May 29, 2026

Version 4

Safety Recall: 2018–22 Odyssey SRS Software Update**Supersedes Version 3 to revise the information at:**

Under REPAIR PROCEDURE A, step 3 has been revised.

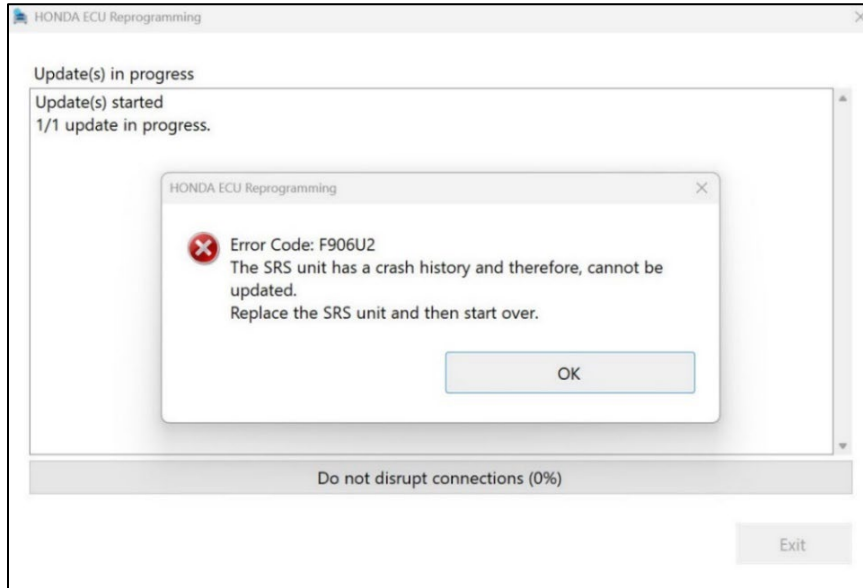
- If the SRS unit cannot be updated and displays the following error message, proceed to **REPAIR PROCEDURE B**.
- A clear photo documenting the HDS screen failure **will be required** for warranty processing.
